Subject: Forward calorimeter

Posted by [StefanoSpataro](#) on Thu, 14 Jun 2007 15:49:33 GMT

1) [fsc_holenew.gif](#), downloaded 960 times

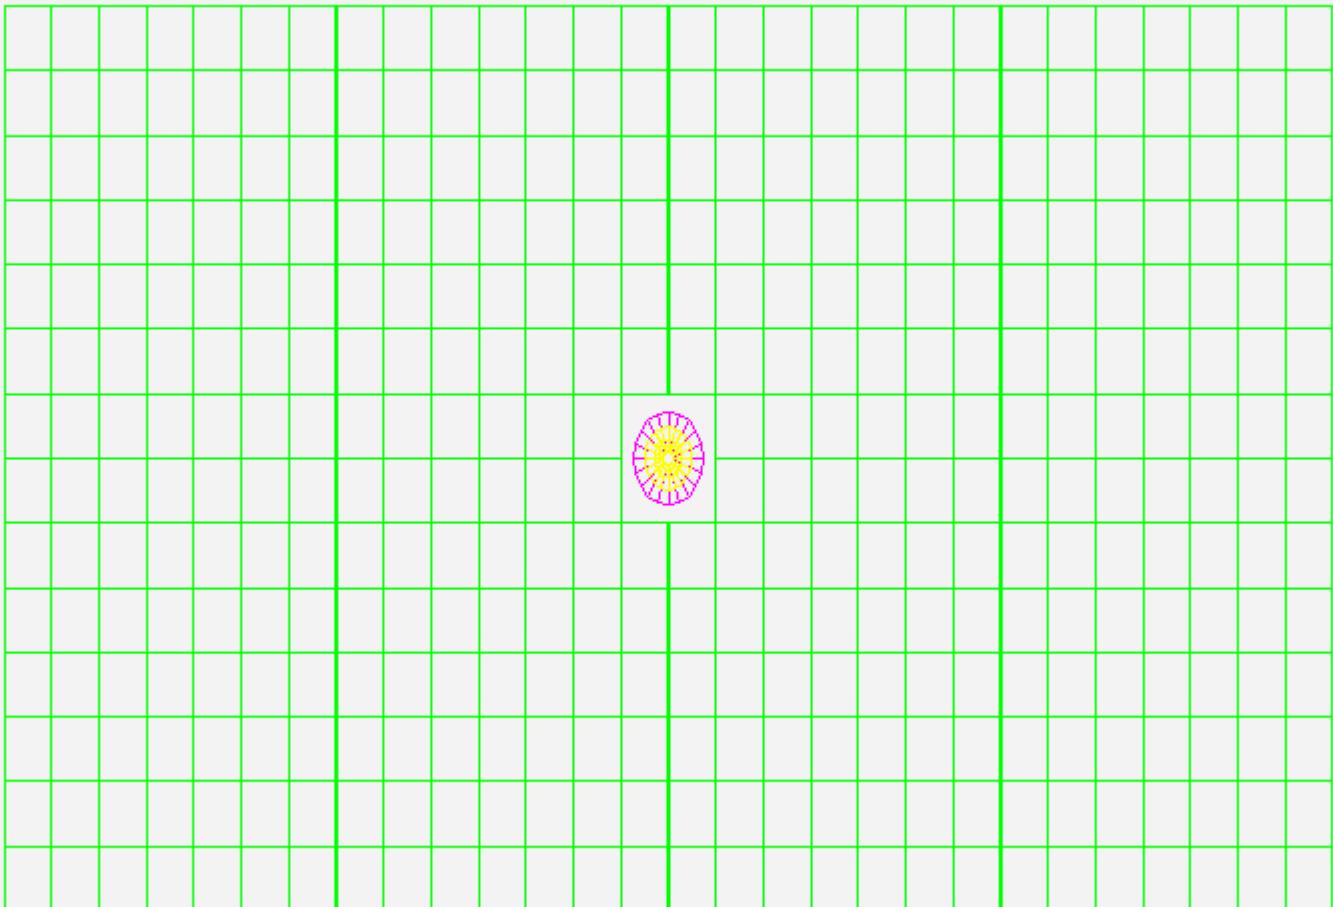
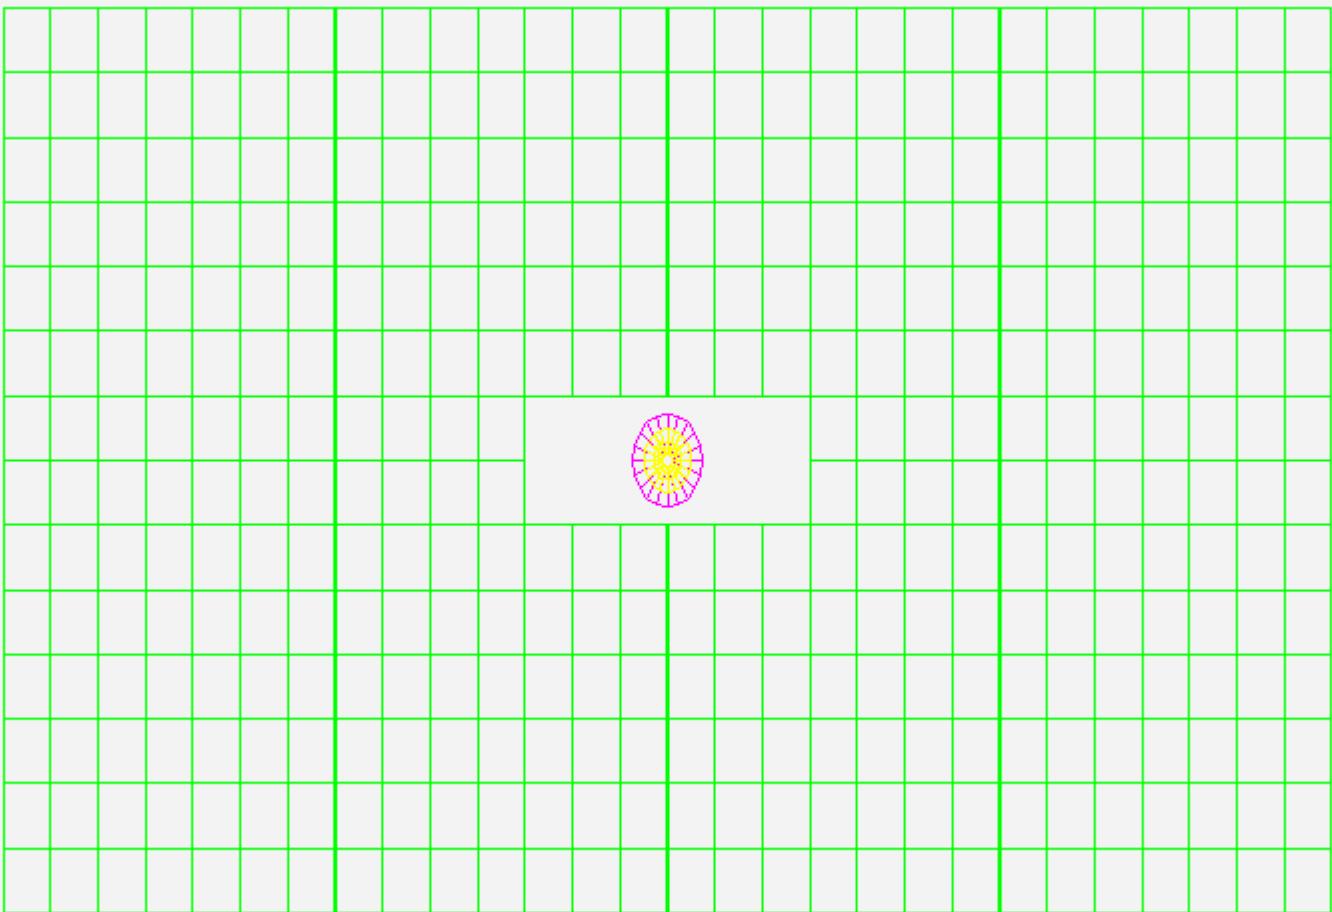
I found maybe one "bug" in the `createGeometry.C`, thus in the geometry of the `fsc`.

I suppose the geometry is defined as the "Chicane" option. Here the position of the hole along X is centred at `hole_xpos = -120.0 [mm]` and not at 0.

But when the "crystals" belonging to the hole are rejected, I found:

```
if(TMath::Abs(curShift.X ()-hole_xpos)<hole_xsize/2+cellxsize/2 && ...
```

In this case the rejected area is from -12 cm to +12 cm, thus we reject 6X2 pads. This is not so clear to me, maybe the `TMath` is not needed there.

In each case, actually in `PandaRoot` we have the "straight" pipe, so the "hole" is the `fsc` region should be around $2\text{X}2 \text{ cm}^2$, thus only 2X2 pad missing.

Just to show the differences.

This is the actual geometry inside svn:

This is what I have, reducing the hole:

As for the geometry, in particular the location and the dimensions of the hole, I still believe that my implementation was right.

I looked into the geometry created with my old macro (still in the release 785). The picture looks differently from what you were showing, because the hole was not central!

Moreover, the rejected area is not, as you write, from -12 cm to +12 cm! The formula suggests

that the gap in X is $\text{hole_xsize}/2$ (because $2*\text{cellxsize}/2$ is occupied by crystals adjacent to the hole) and is centred in hole_xpos . I do not see what is wrong with it.

The number of rejected crystals depends on the hole position and its size, which were the macro parameters. If you set the $\text{hole_xsize}=200$ and $\text{hole_xpos}=0$ you should get exactly the picture which you are showing as the second one. I assumed the chicane option because I wasn't aware that we only have the straight beam pipe implemented. However, as the chicane is the default solution right now, we'll have to work on implementation of it, too.
